CHANGE ORDER

Project: Woodland High School Project No.: 1119.00-12
 Architect: McGranahan Architects Change Order No.: 2
 Contractor: Skanska USA Building, Inc. Date: February 9, 2014

CONSTRUCTION CHANGE DIRECTIVE: 002 R1

Woodland High School

TITLE: LEVEL 0 - PLUMBING PLAN - INDUSTRIAL TECH REVISION
REFERENCE: 2 / M247
SCALE: 1/4" = 1'-0"
ISSUED FOR: RFI-0026, RFI-0029
DATE: 01/13/14

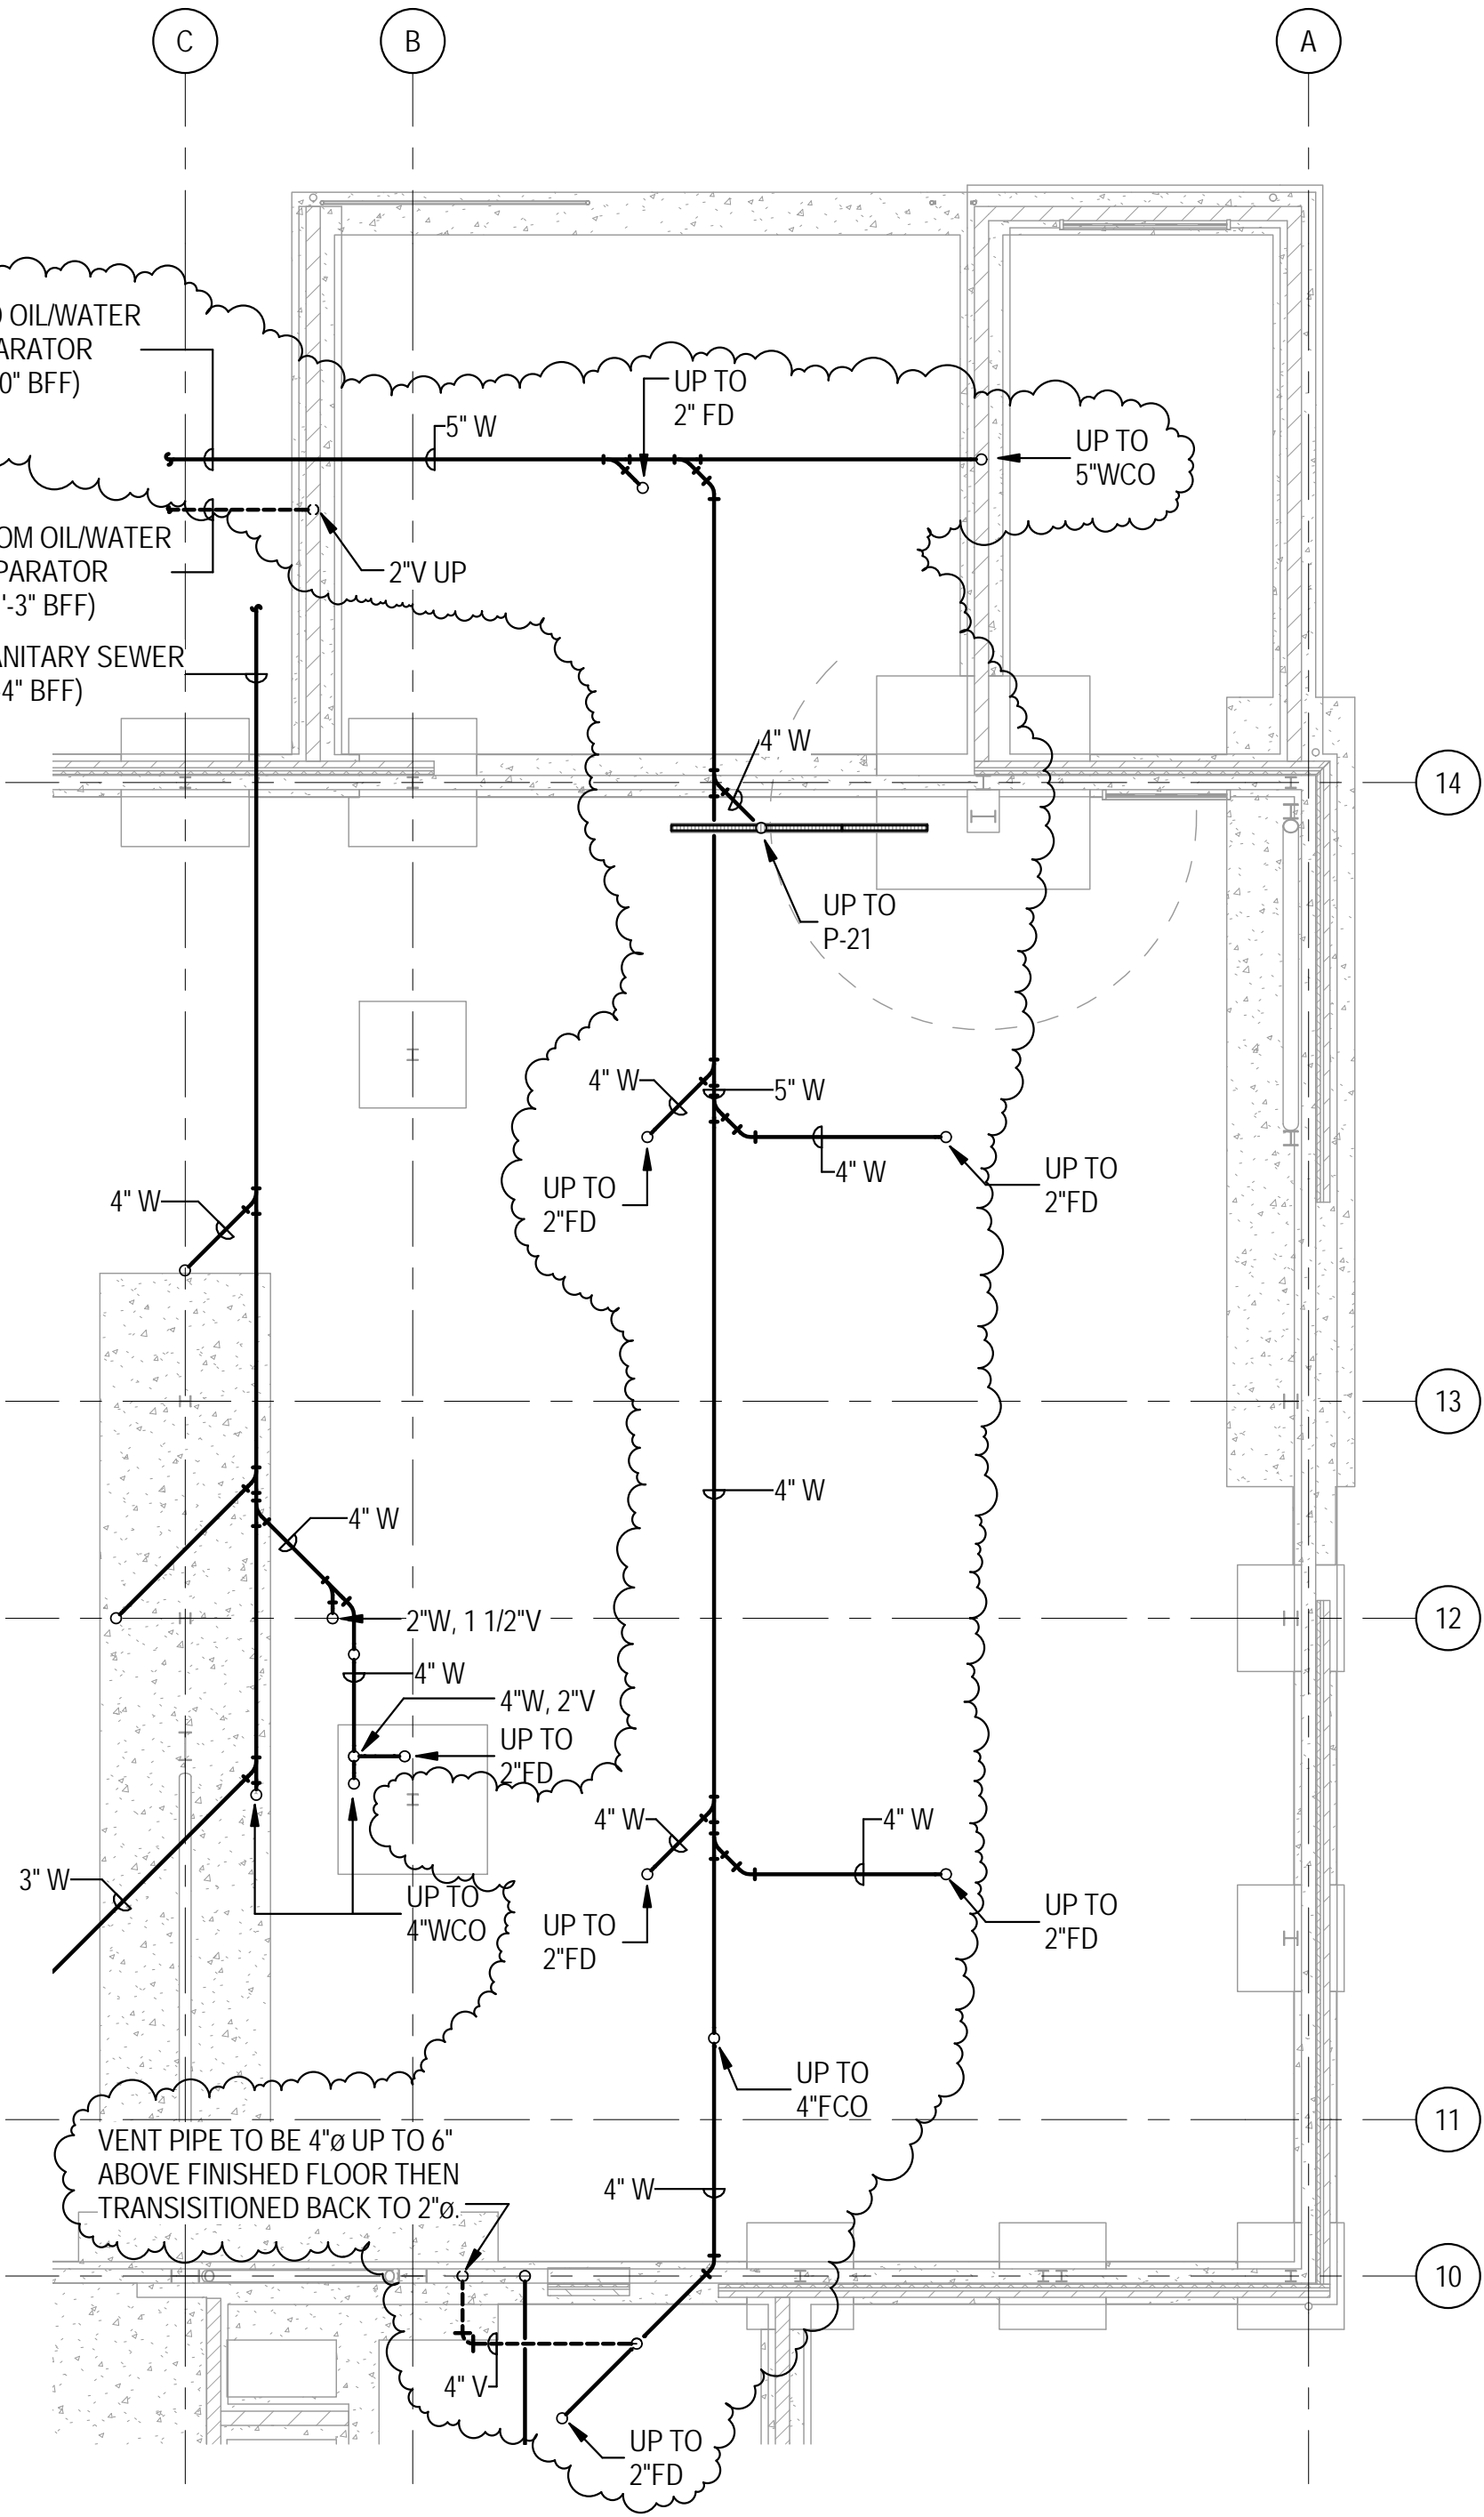
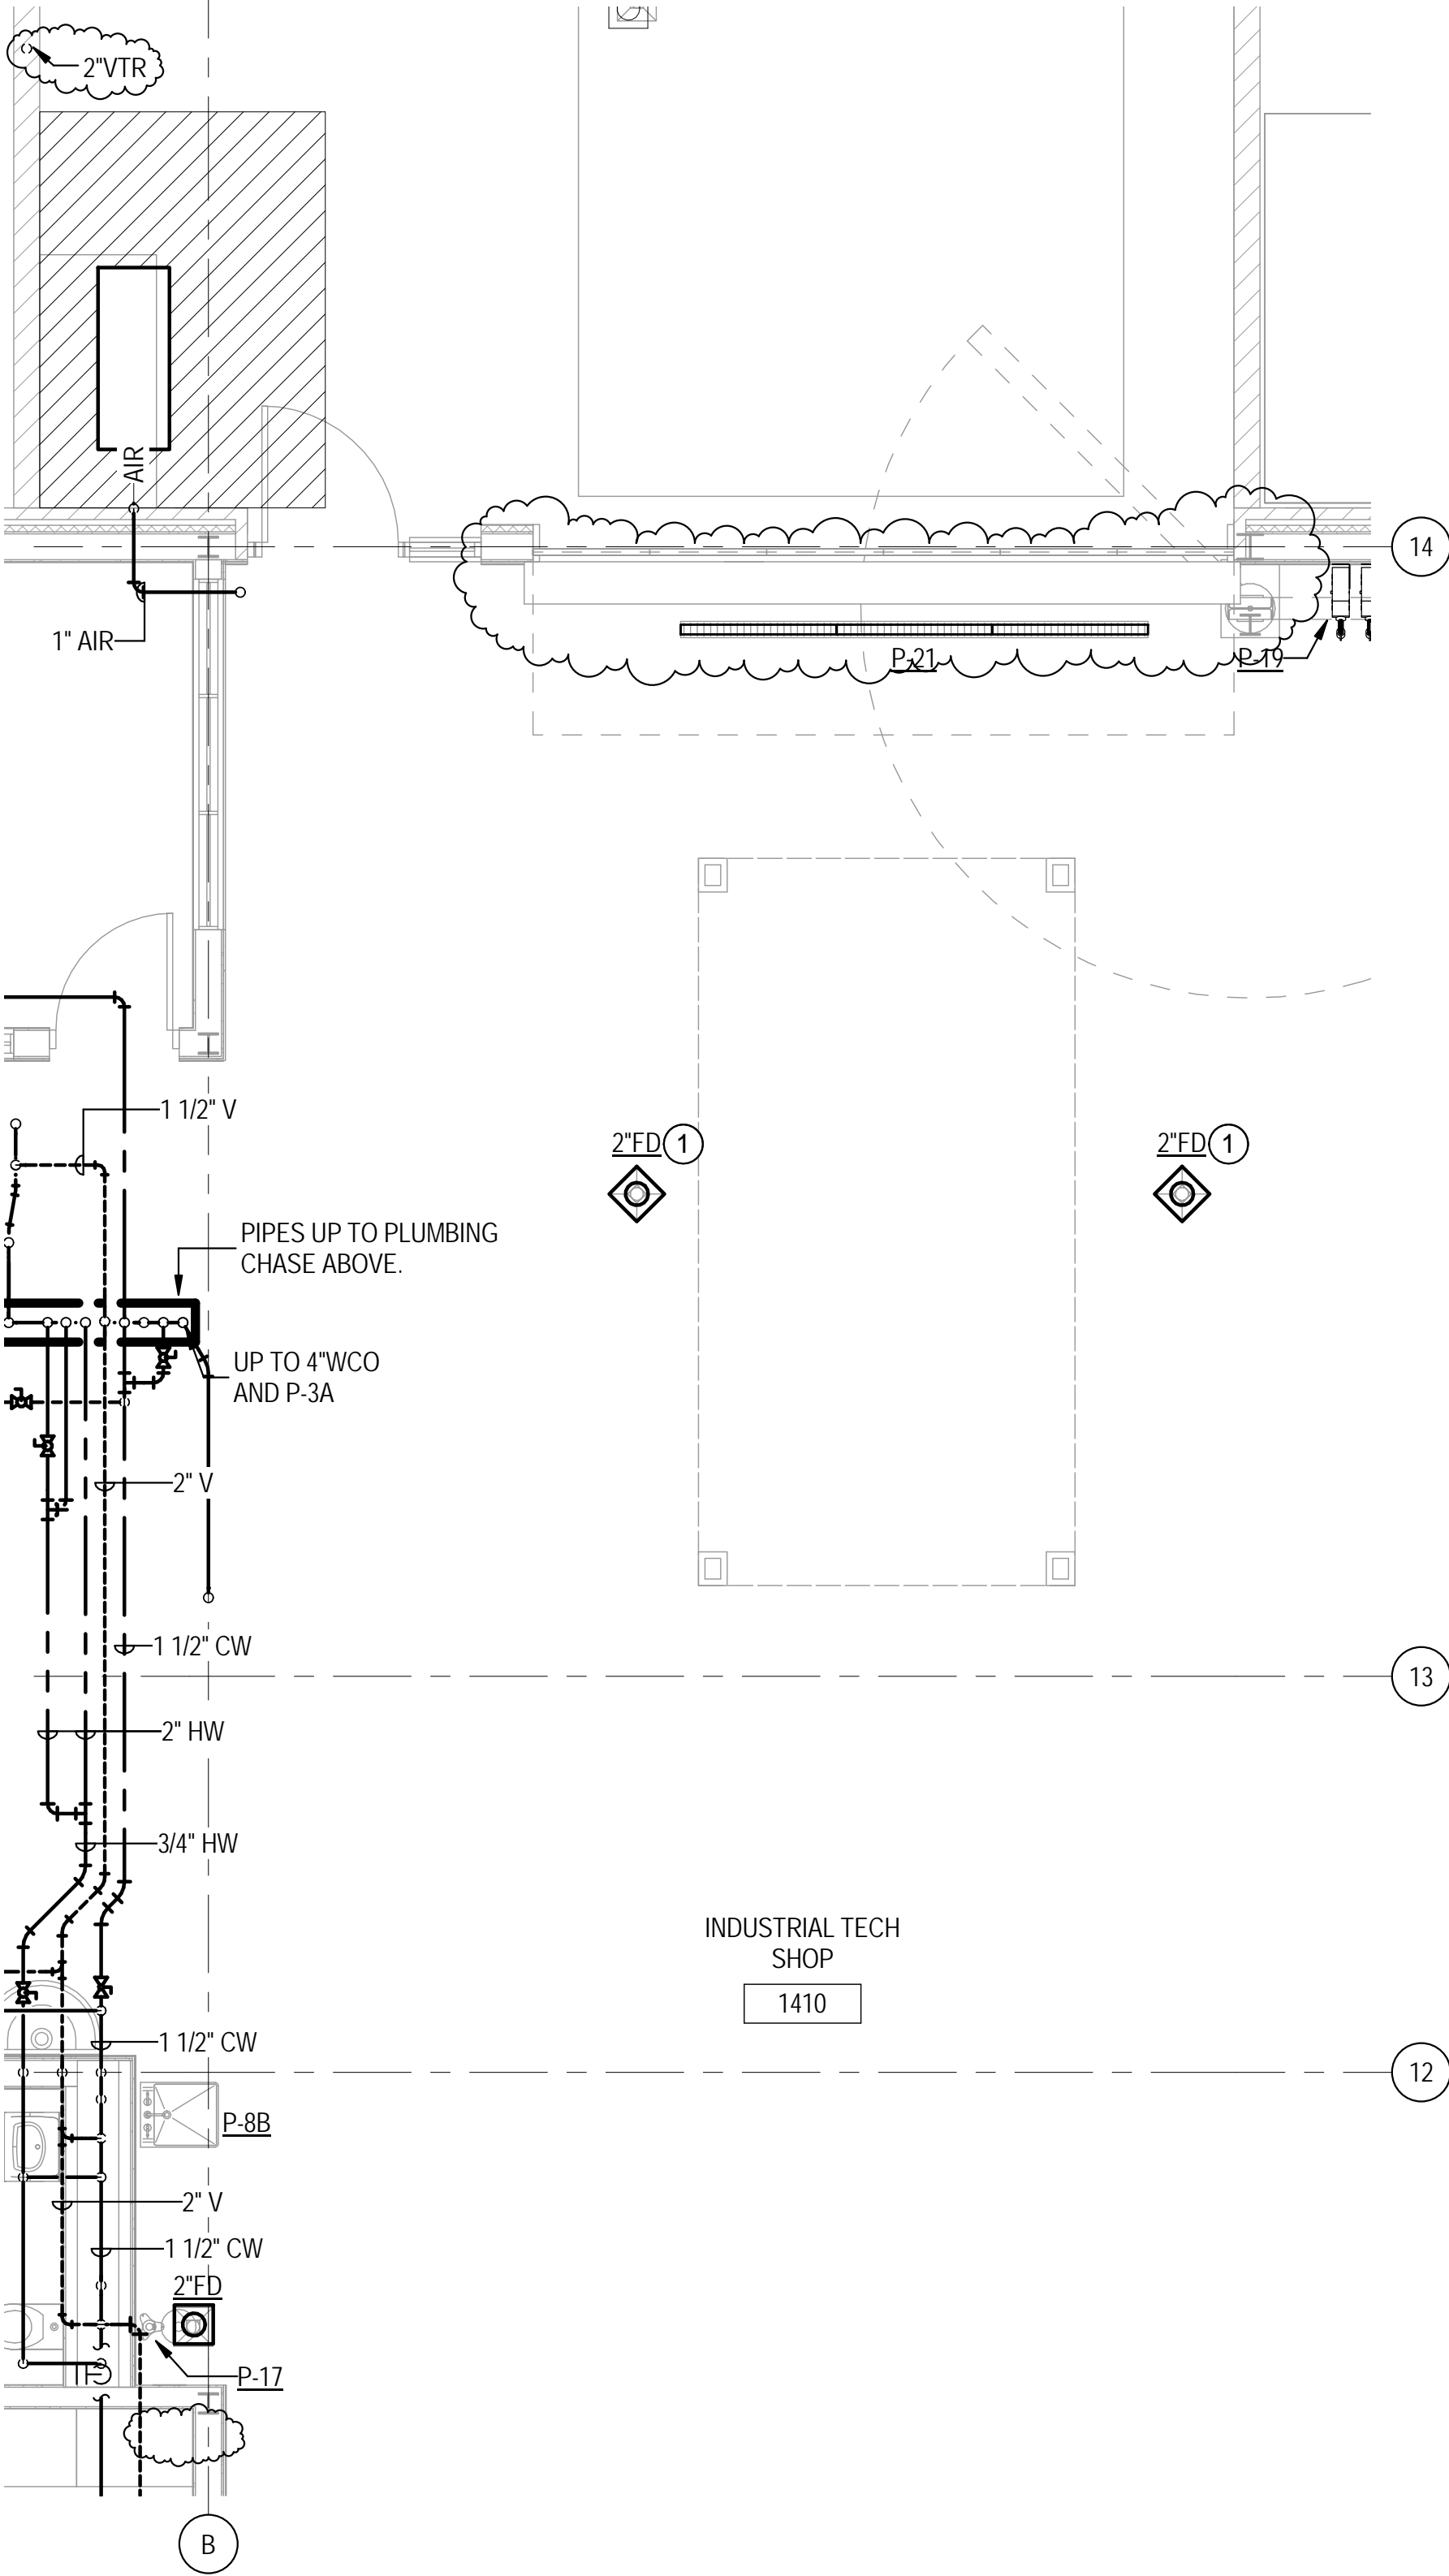
The plans on Page M2.03 indicate the 2" oil waste line has a starting invert of -3'-0"BFF, with 130' feet of pipe (ran at 1/4" per ft.) the invert at the furthest floor drain will be -0'-3" BFF.
The invert will need to be lowered a min. of 12" to allow for the p-trap, vent and floor drain to be installed.
Please advise

The plans on M2.03 (on the oil/water separator line) and M2.05 (in the locker rooms) are showing the vents from the floor drains being connected to each other below the flood rim level of the fixture they serve. The plumbing code requires that they rise a min. of 6" above the flood rim level before any vent can be to another vent.

Modify waste and vent piping as shown on sketches MSK-066, MSK-067, and MSK-068.
